Government of India
Ministry of Railways
Research, Designs & Standards Organisation

Ref. No. EL/3.2.10/8/JCG

MODIFICATION SHEET No. RDSO/WAM4/111

PROVISION OF CAPACITOR ACROSS CUTLER HAMMER TIME DELAY
RELAY COIL (Q 48)

REVISED CABLE CONNECTION
FOR 048

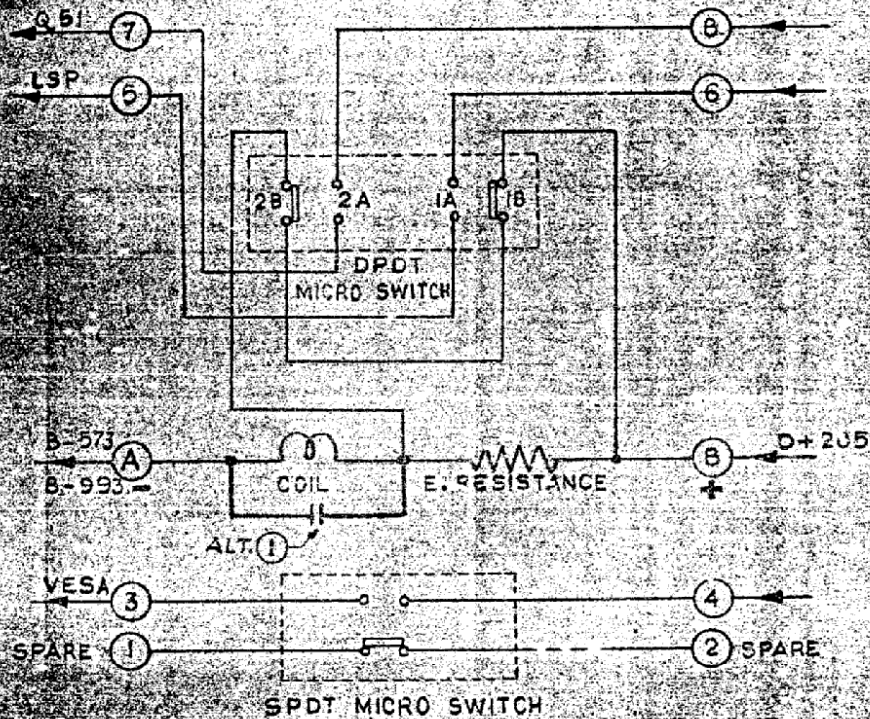
Railways have reported several failures of D.P.D.T. micro switch contacts and coils as well. Intense sparks have been observed at the interlock contacts across the economy resistor. Tests have shown that a 1 microfarad capacitor across the relay coil eliminates the arcing across the contacts. The object of this modification is to minimise the arc intensity across the self interlock and thus prevent welding of contacts and burning of the coil.

- 2.1 Ensure that relays have been modified already as per modification sheet No. RDSO/WAM4/110 dated 18.2.81.
- 2.2 Crimp the sockets to the capacitor axial leads. Ensure that the total length between lugs is not less than 160 mm.
- 2.3 Fix the capacitor over the top of the SPDT switch cover with the help of the araldite. Avoid sharp bends and strain on the capacitor leads.

- One capacitor 1/4W 10% rated capacitance and 630/500 V rated voltage (dc) with axial leads conforming to IS: 4633 (category 1)
(Note: total length shall not be less than 160 mm).
- Two sockets, crimp type similar to M/s Dowell's catalogue No. RS-7103A3
